Re: Indian Point Unit 2  
Docket No. 50-247  
NL-06-011

**Subject: Response to Request for Additional Information regarding  
LAR for Pressurizer Level Requirements (TAC MC7061)**

**REPLY TO NRC REQUEST FOR ADDITIONAL INFORMATION REGARDING  
PROPOSED LICENSE AMENDMENT REQUEST FOR  
INDIAN POINT 2 PRESSURIZER WATER LEVEL REQUIREMENT**

FIGURE ONE - REPRESENTATIVE DENSITY COMPENSATION CURVE

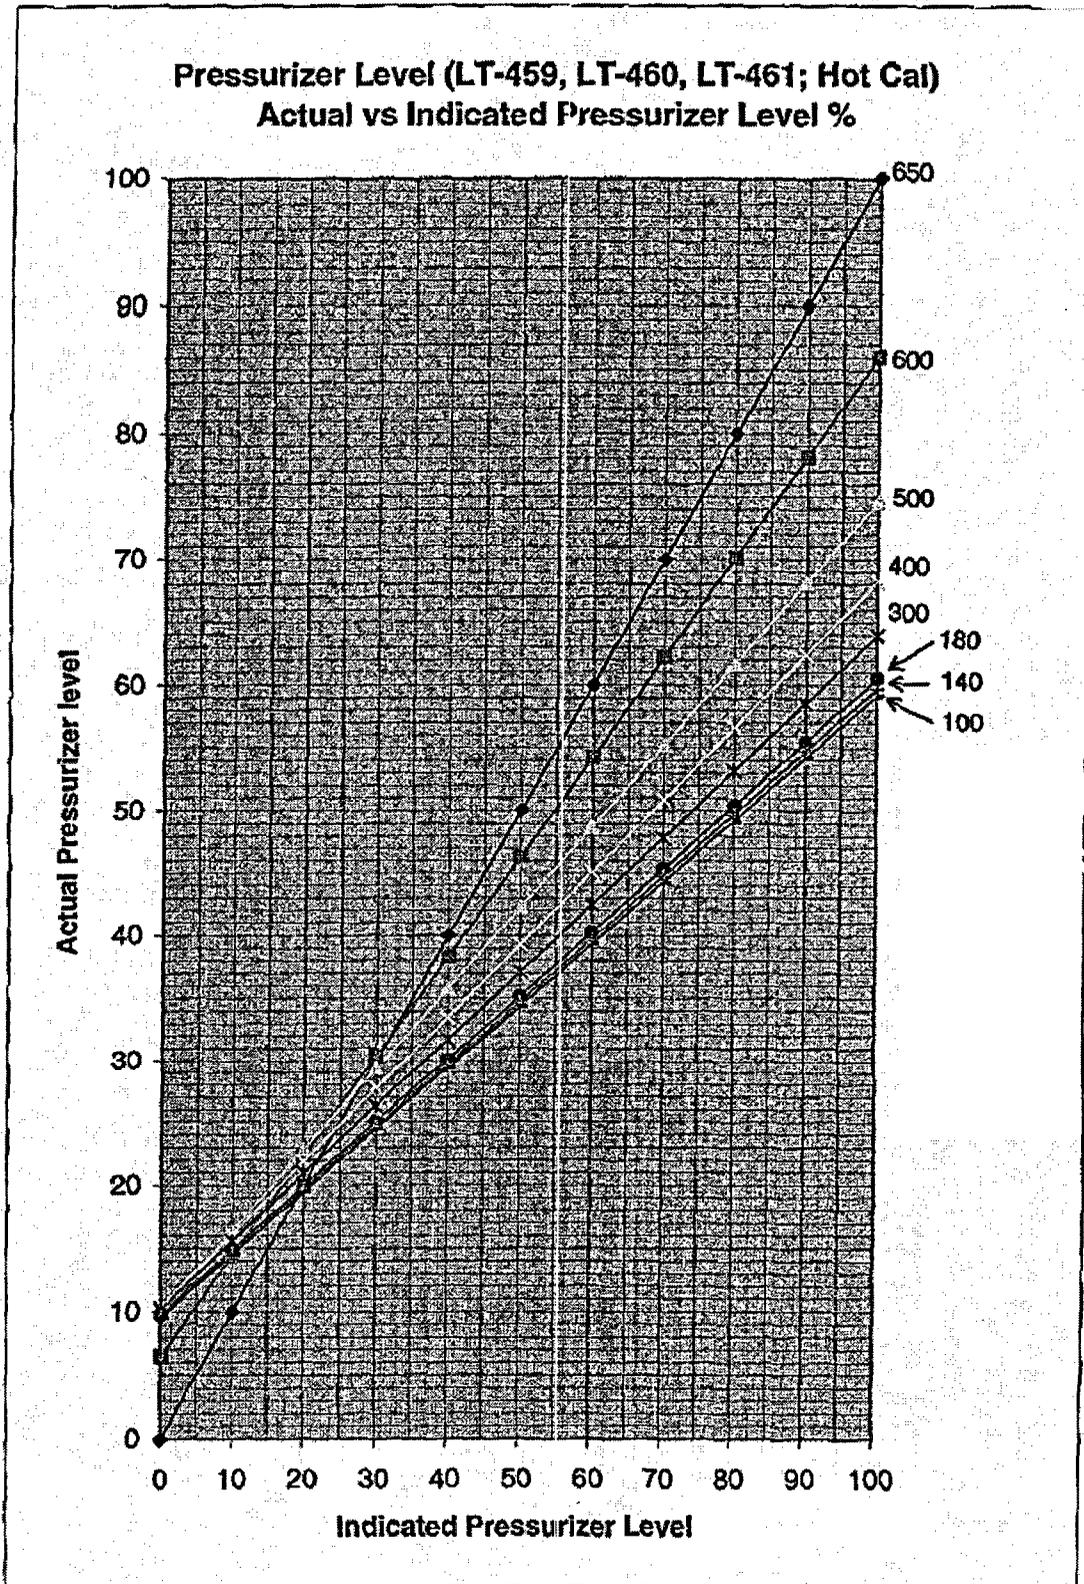
The licensee stated in its amendment request that the instrument channel indicators for the pressurizer level must be adjusted by plant operators using density compensation curves when the pressurizer is not at the temperature used for the instrument channel calibration. Since the temperature range for the Mode 3 operation is defined in the TSs, the licensee should be able to calculate the maximum uncertainty in the indicated pressurizer level under the most limiting Mode 3 conditions. The NRC staff requests that the licensee identify the maximum uncertainty, describe the methodology used to perform the calculation, and provide a technical justification for why this uncertainty is bounding.

The above instrument uncertainty values are valid for the full range of temperature, from a cold condition to normal operating temperature, as long as operators apply the applicable density compensation adjustment based on indicated fluid temperature in the pressurizer. Figure One is a sample density compensation curve for the hot calibrated instrument channels. Operating procedures are already in place that require operators to use density compensation curves if the process temperature is not at the calibration temperature for that instrument channel.

Therefore, when using the hot-calibrated channels, operators average the readings from two of the three indicators, apply density compensation if needed, and compare the result to the Technical Specification limit. When using the cold-calibrated channel, density compensation is applied if needed to the reading available from the single channel to compare to the Technical Specification limit. This approach is currently in place for the existing Technical Specification limit. This approach will also apply for the proposed new technical specification which establishes a new limit in Mode 3 that is different from the Mode 1 / 2 limit.
